ECE/TRANS/WP.29/GRSG/2009/20  
10 August 2009

**REGULATION No. 125**  
(Forward field of vision of drivers)

Proposal for draft amendments to Regulation No. 125

Submitted by the expert from France \*/

**"Figure 7: Definition of the area 'S'  
 (paragraph 5.1.3.2.)**

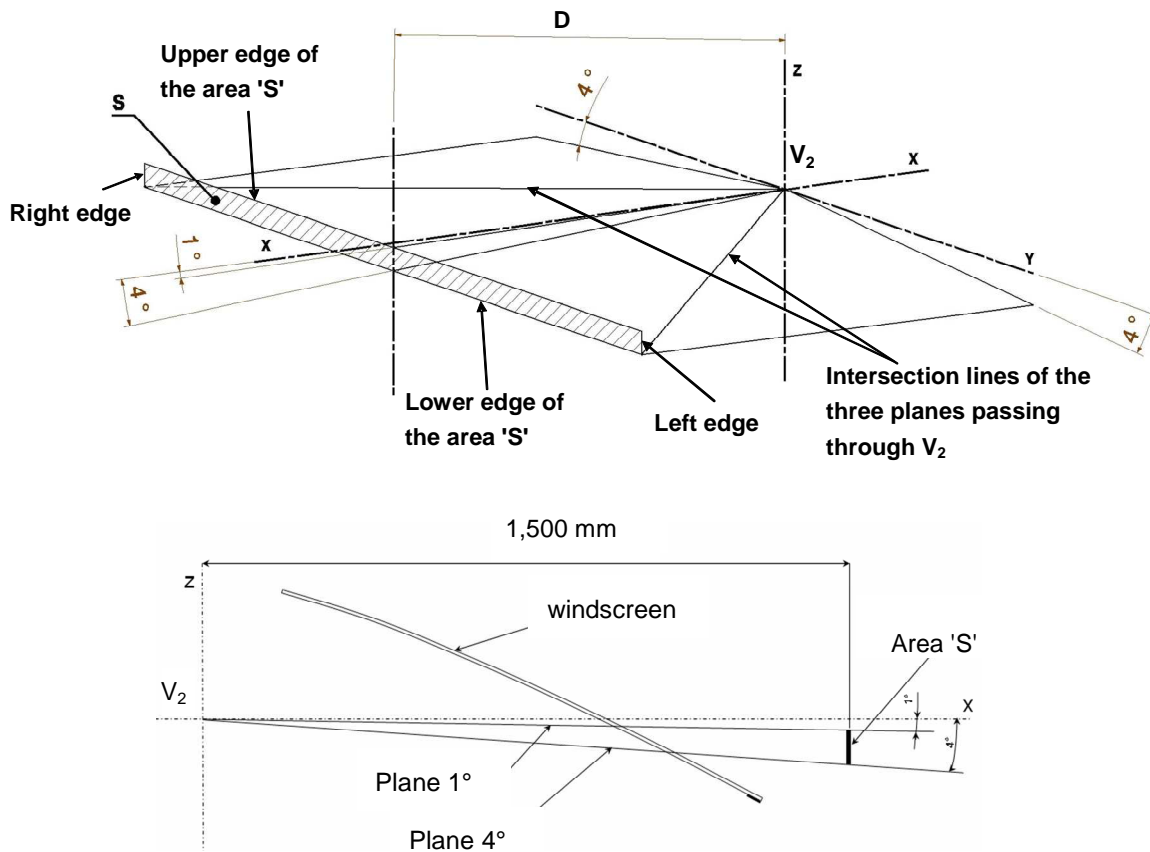
"5.1.3.2. The area 'S' (see Annex 4, Appendix, figure 7) is a rectangular vertical area located in a plane perpendicular to the X coordinate 1,500 mm forward of the point  $V_2$ . The upper edge of the area 'S' is defined by a plane passing through  $V_2$  declined forward  $1^\circ$  below the horizontal. The lower edge of the area 'S' is defined by a plane passing through  $V_2$  declined forward  $4^\circ$  below the horizontal. The left and right edges of the area 'S' are vertical and generated from the intersection lines of the three planes declined  $4^\circ$  as defined in paragraph 5.1.3. above.

5.1.3.3. In the case of a windscreen extending beyond 1,500 mm forward of the point  $V_2$ , the distance between the area 'S' and the point  $V_2$  may be extended accordingly."

Annex 4, Appendix, insert a new figure 7, to read:

Figure 1 : Illustration of the obstruction area between  $1^\circ$  and  $4^\circ$  planes below the horizontal in the current text.

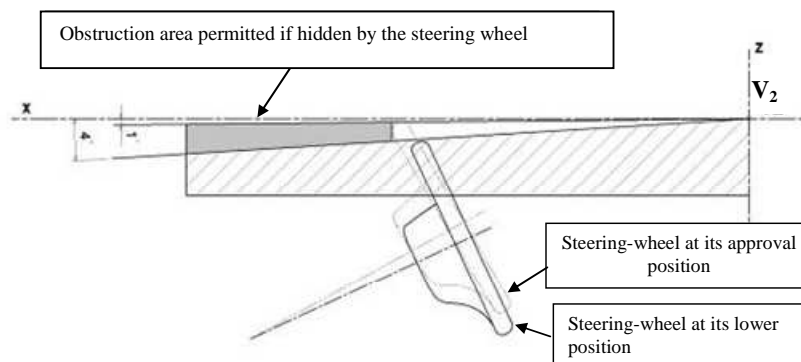
The current text of the Regulation prohibits an obstruction above a plane declined  $4^\circ$  except for an obstruction created by the rim of the steering-wheel and the instrument panel inside the steering-wheel in the boundary of the plane declined  $1^\circ$  below the horizontal. As a consequence, all driving information, or the instrument panel, must necessarily be located below the plane declined  $4^\circ$  (see figure below).

Figure 2: Illustration of the obstruction area by a display area.

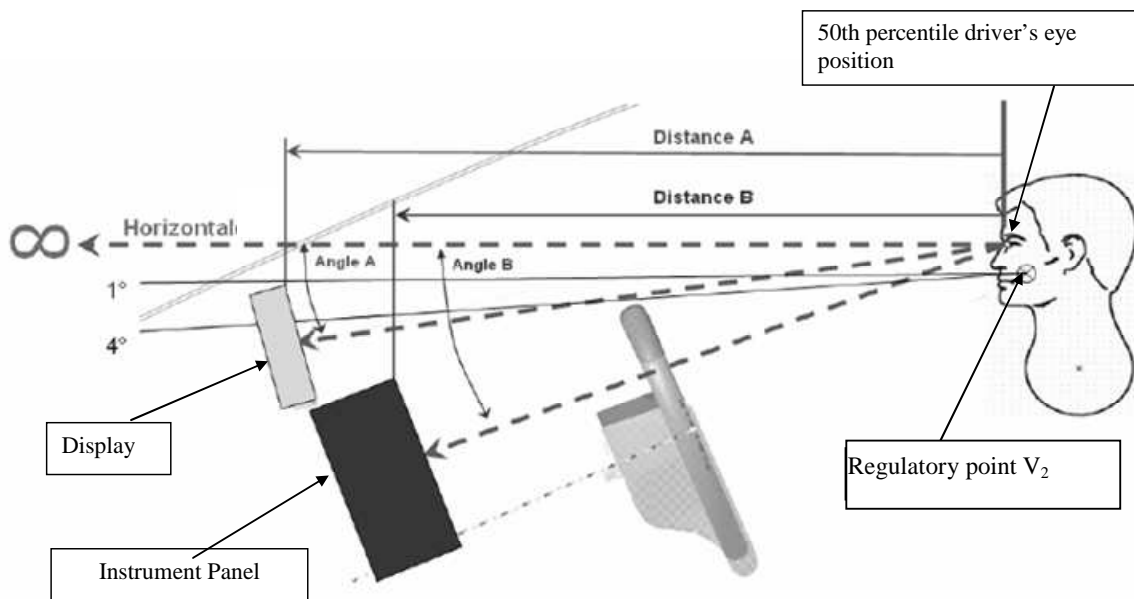
The driver's eyes must leave the road in order to analyse all the information inside the instrument panel (for example speed, warning tell-tales, etc) (see angle B in the figure 2 below, illustrating the real world driving situation). Thus, the road is temporarily outside the forward field of vision of the driver.

The proposal (as illustrated above) allows the placement of a visual display unit, located above the steering-wheel, at the boundary of the plane declined  $1^\circ$  below the horizontal, and containing the essential information of the instrument panel. This in consequence will improve the availability of the most important driving information with no influence on the forward vision of the driver. The driver can therefore consult this information while keeping the road in his field of vision. The main advantages of this proposal are:

- (a) An ocular angle A (in the proposed text) lower than ocular angle B (in the current text),
- (b) Important driving information concentrated in the forward vision of the driver.

Figure 3: Illustration of efficient usage of obstruction allowance.

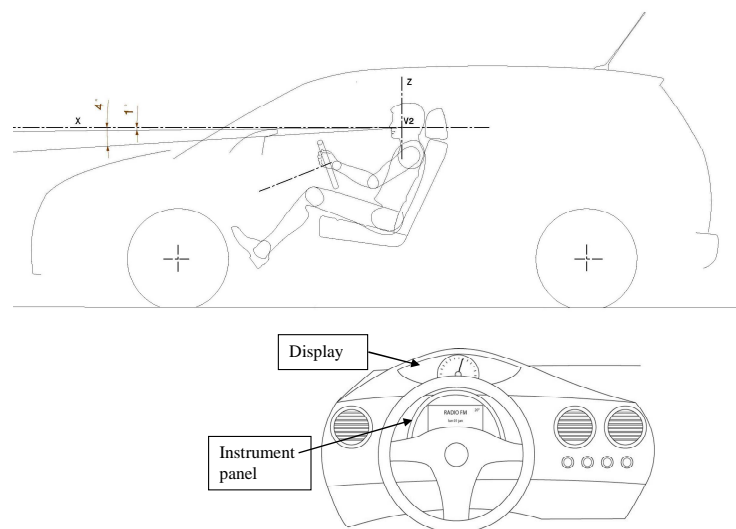
The obstruction allowance of the current text, delimited by the  $4^\circ$  and the  $1^\circ$  declined planes (see figure 1) is kept in order to keep the spirit of the current text. The objective is to improve the driver's forward vision in accordance with the current obstruction tolerance for the important driving information in this area. An illustration of the proposal is given in figure 3 below.

Figure 4: Example of an obstruction zone.

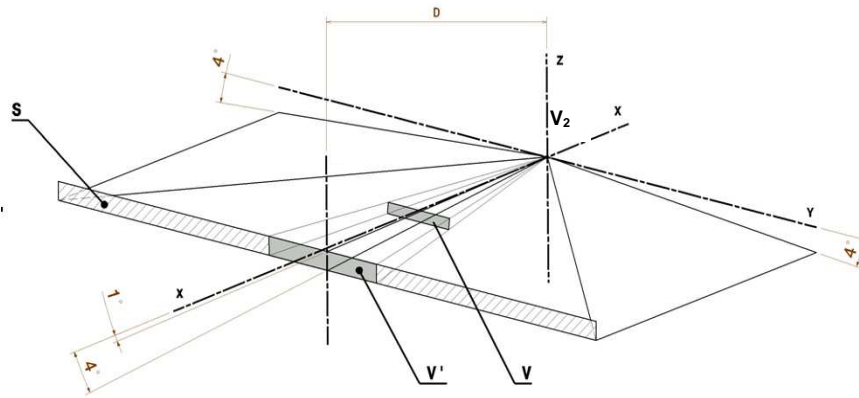
The current regulation permits an obstruction by the steering-wheel between the  $1^\circ$  and  $4^\circ$  declined planes with no limitation on the size of the steering-wheel. This obstruction area, by geometrical projection on the area 'S', cannot in general exceed 17 per cent for a normal steering-wheel. In order to take advantage of this obstruction allowance, the driving information located there must in addition respect the size of display as prescribed by Regulation No. 121 (Identification of controls, tell-tales and indicators). Their entire integration justifies a 20 per cent obstruction area. As illustrated in figure 4 below, the obstruction area is 19.77 per cent (V area in the figure) for an LCD and its trim width of 340 mm located in the boundary of the  $1^\circ$  plane.

The calculation method is as follows: project the V area to the area 'S' from the  $V_2$  point in order to obtain the V' area. In the illustration, the area 'S' is about 235,858 mm<sup>2</sup> and the V' area is about 46,637.9 mm<sup>2</sup>.
